**Safety Evaluation Report for the  
Justification for Dual-3013 Contents, Addendum 7 to  
Safety Analysis Report for Packaging Model 9977**

Docket Number: 11-41-9977

Prepared by: James M. Shuler Date: 7/30/12  
James M. Shuler  
Manager, DOE Packaging Certification Program  
Office of Packaging and Transportation

**Figure 1.2 – 9977 Package with Heat Dissipation Sleeve**

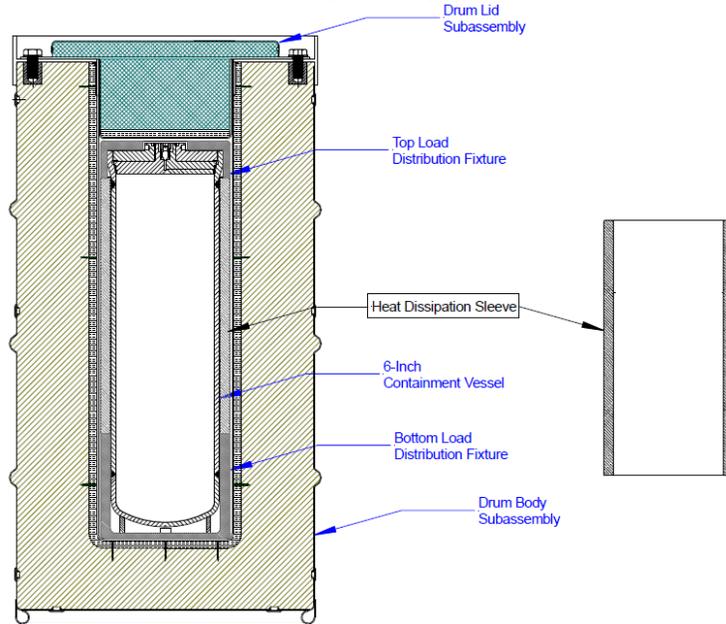
An aluminum Heat Dissipation Sleeve (HDS), shown in Figure 1.2, outside the CV has been added to enhance heat transfer from the package because of the increased decay heat load of the Dual-3013 contents. In addition, the CV is fitted with an aluminum 3013 Spacer to fill the space between 3013 container assemblies and the inner wall of the CV, as illustrated in Figure 1.3.

The HDS is made from 6061-T6 aluminum, surrounds the outside of the 6CV within the Drum Liner cavity, and is located between the Top and Bottom Load Distribution Fixtures (see Figures 1.2 and 1.3). The HDS enhances the conduction of content decay heat out of the 6CV and produces a more uniform temperature distribution, eliminating “hot spots” within the package, particularly in the PU foam.

In Revision 2 of the 9977 SARP, the structural performance of the 9977 packaging was evaluated without the HDS. Additional structural analysis was conducted in Addendum 7 to investigate the effect of the addition of the HDS on the structural performance of the 9977 packaging. Table A.2.2 of Addendum 7 shows that following the 30-ft free drop on the side of the package, the CV would experience less stress with the HDS in place. DOE PCP staff performed confirmatory analysis to evaluate the effects of the HDS under HAC for a 30-ft drop and sequential crush. DOE PCP staff-calculated results are given in Table 2.1, which shows that the maximum stress and deformation of the CV are less if the HDS is installed in the 9977 package.

**Figure 1.3 – 9977 Package with PuO<sub>2</sub> Content in Dual-3013 Container Assemblies**

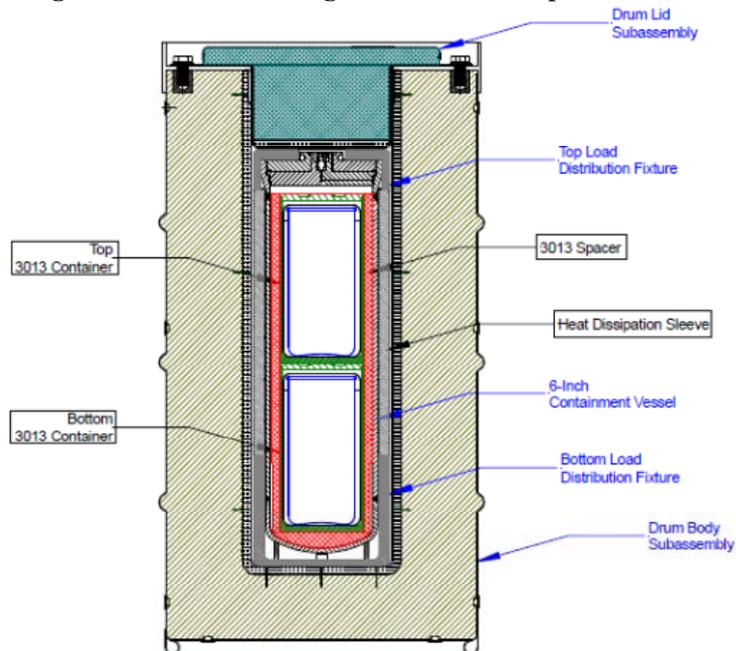
Figure 1.3 depicts a typical shipping configuration of the 9977 package, with PuO<sub>2</sub> contained in Dual-3013 container assemblies. The aluminum HDS is outside the 6CV, between the top and bottom LDFs; Dual-3013 containers are fitted into the aluminum 3013 Spacer, one above the other.

**Figure 5.1 – (a),(b) NCT and HAC Models Evaluated in Addendum 7; and (a)-(d) Confirmatory Analyses. The PuO<sub>2</sub> contents are shown in color.**

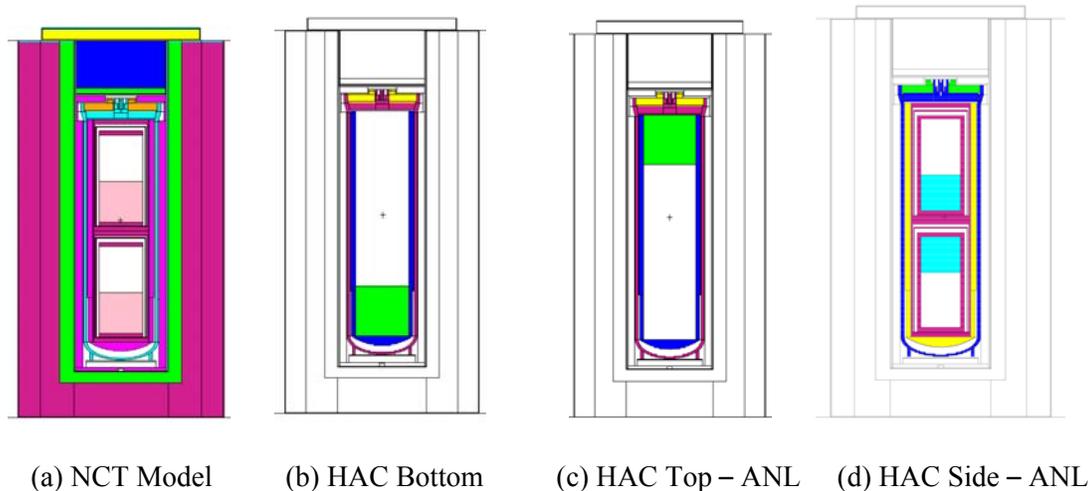
The geometry of the shielding analysis model used in Addendum 7 is a homogeneously distributed, cylindrical representation of the PuO<sub>2</sub> content in the Dual-3013 configuration, as shown in Figure A.5.1 of Addendum 7. The configuration consists of 5.0 kg of PuO<sub>2</sub> powder compacted at 7 g/cm<sup>3</sup> within the convenience cans in cylindrical form in each of the Dual-3013 containers. In Addendum 7 shielding models, all materials inside the CV are modeled explicitly, including the 0.08-cm-thick convenience can, inner 3013 container, and outer 3013 container. In the NCT model, the surface of the drum is considered to be the package surface, where dose rates are calculated. In HAC models, Addendum 7 assumes a total loss of all package components outside of the CV, but the CV and content remaining intact. Thus, the surface of the 6CV is considered as the package surface in the HAC dose rate calculations. The Addendum 7 evaluation further assumed that the PuO<sub>2</sub> contents from the Dual-3013 containers are combined into one compact cylinder filling the CV bottom within the aluminum sleeve. This is a very conservative assumption, since it maximizes the neutron subcritical multiplication. DOE PCP staff has confirmed the dimension of the shielding geometry and verified that the model assumption used in Addendum 7 for the dose rate calculations is conservative.

The bounding cases for the shielding calculations must be determined by comparing radiation dose rates from various models with different PuO<sub>2</sub> content shapes and locations within the CV. Addendum 7 evaluated homogeneously distributed cylinder models initially and then only considered the compact cylinder models shown in Figure 5.1(a) and (b) of this SER. DOE PCP staff confirmatory analysis evaluated compact sphere, cylindrical shell, homogeneous cylinder and compact cylinder models, as shown in Figure 5.1. DOE PCP staff obtained the highest HAC dose rates for the compact cylinder models in configuration (c) (HAC Top – ANL), because the PuO<sub>2</sub> source material is near the top of the CV, and in configuration (d) (HAC Side – ANL), because the two PuO<sub>2</sub> source materials are adjacent and located at the middle of the CV.

In the shielding evaluations, the content is represented by a compact cylinder of PuO<sub>2</sub> powder filling the interior of the convenience can within the 3013 inner container. Furthermore, DOE PCP staff found that a compact cylinder model produces the highest dose rates for the 9977 package when the two PuO<sub>2</sub> contents are resting on the bottom of the 3013 inner container under NCT. Dose rates are highest when modeled with 7.0 g/cm<sup>3</sup>-density PuO<sub>2</sub> content as a compact cylinder with a radius of 4.92 cm and a height of 9.372 cm, dimensions that preserve the total mass of 5 kg of PuO<sub>2</sub>. The geometrical configuration of the neutron dose rate calculation model is identical to the configuration of the photon dose rate calculation model.
